Invitation For Bid: IFB-05-ENG-2026

Project: Ypao and Mamajanao Wastewater Pump Station Rehabilitation,
GWA Project No. 22607

Addendum No.: **06**

Date: July 13, 2026

A-10

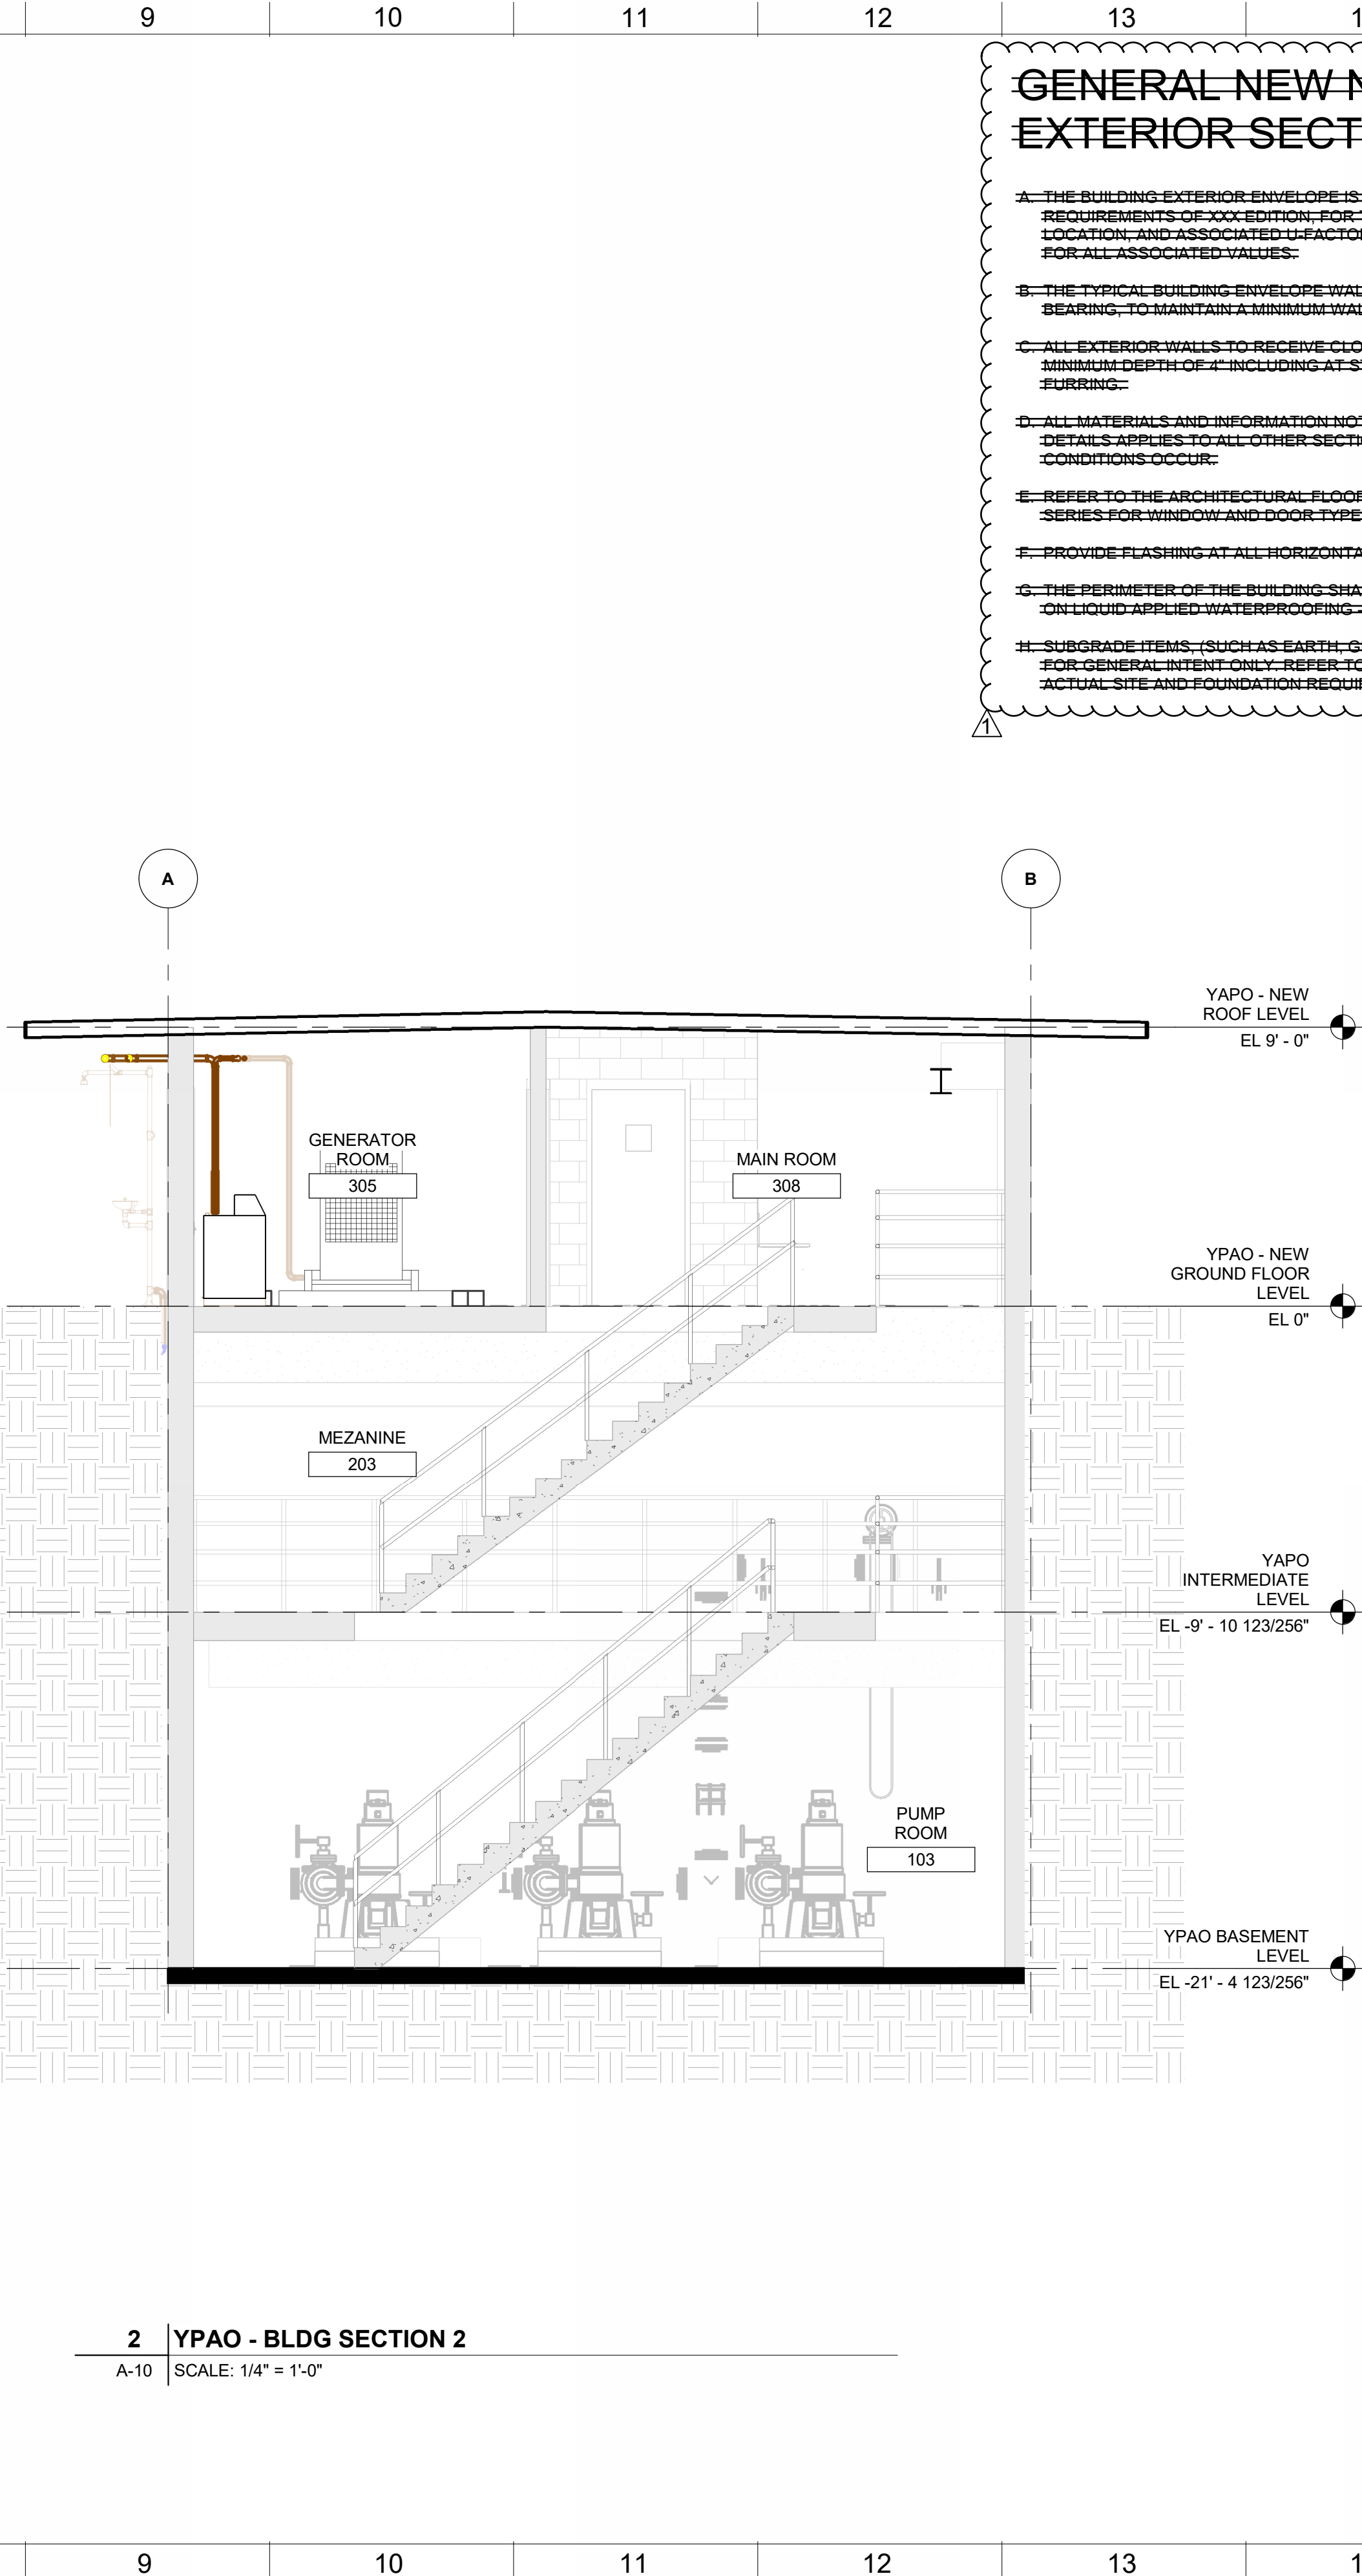
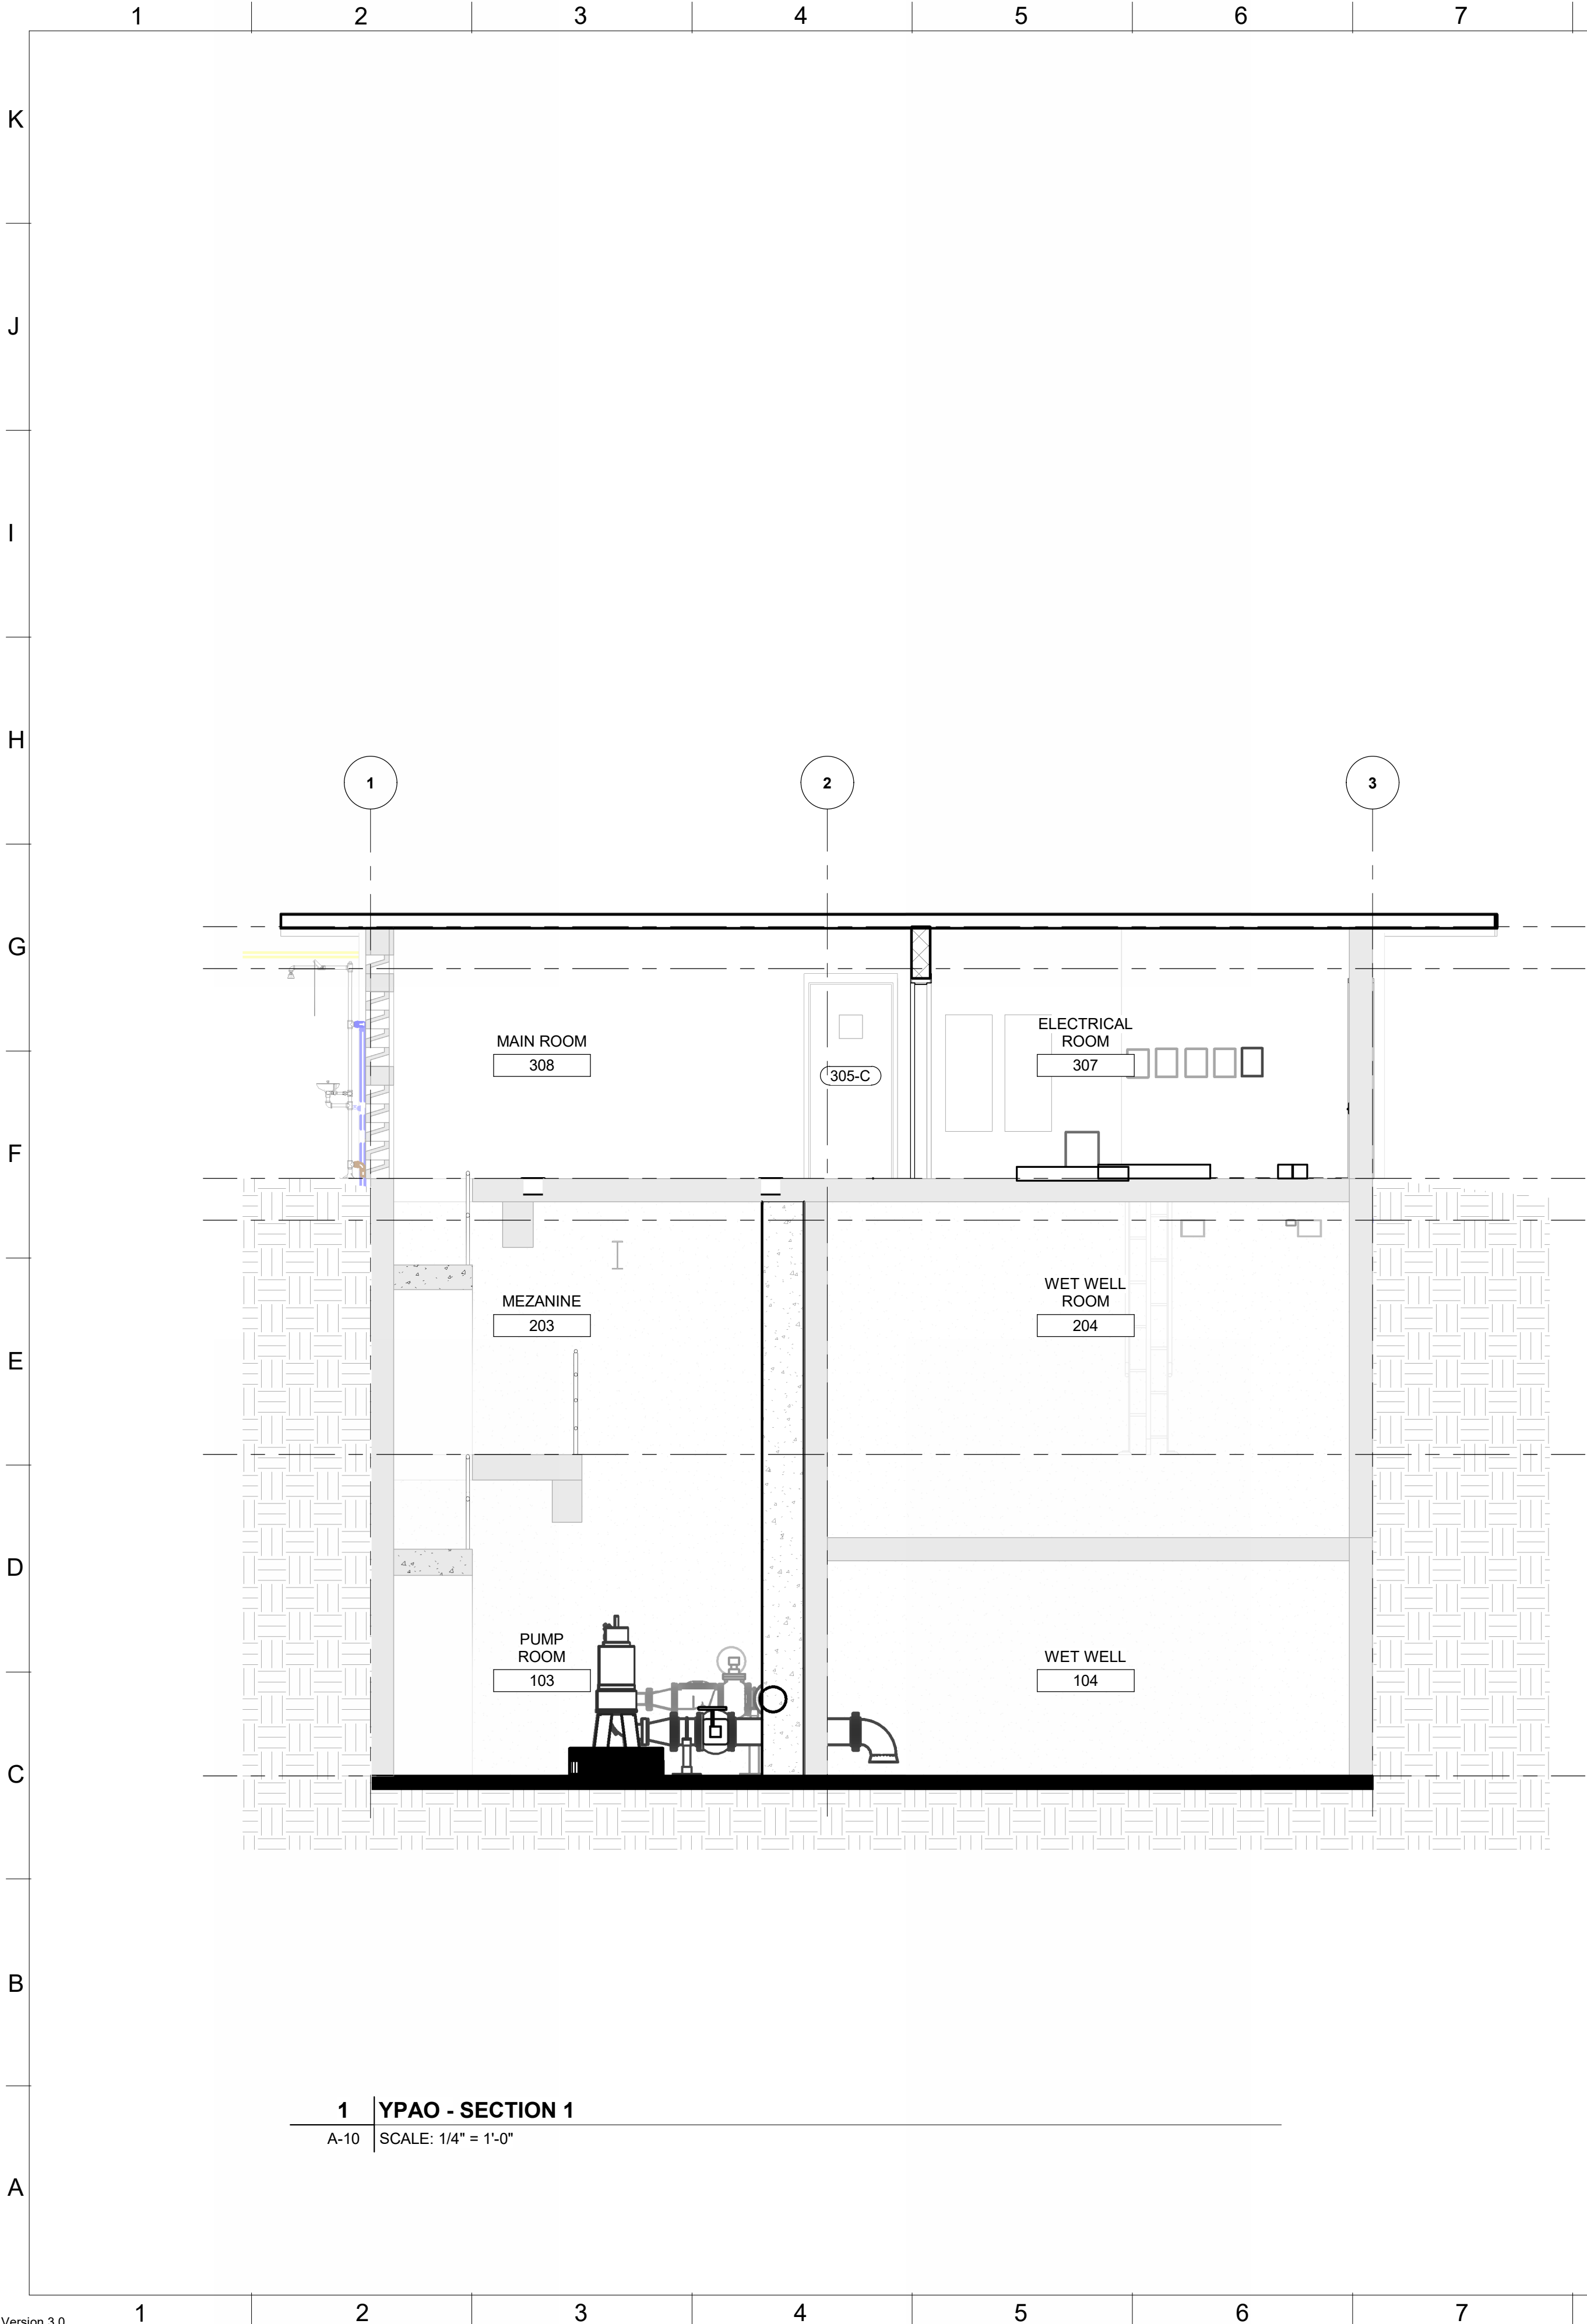
- Ypao SPS- Sheet A-10 Note removal

NO.	REVISIONS:	DATE:
1	ADDENDUM NO. 6 - NOTE REMOVAL	7/10/26
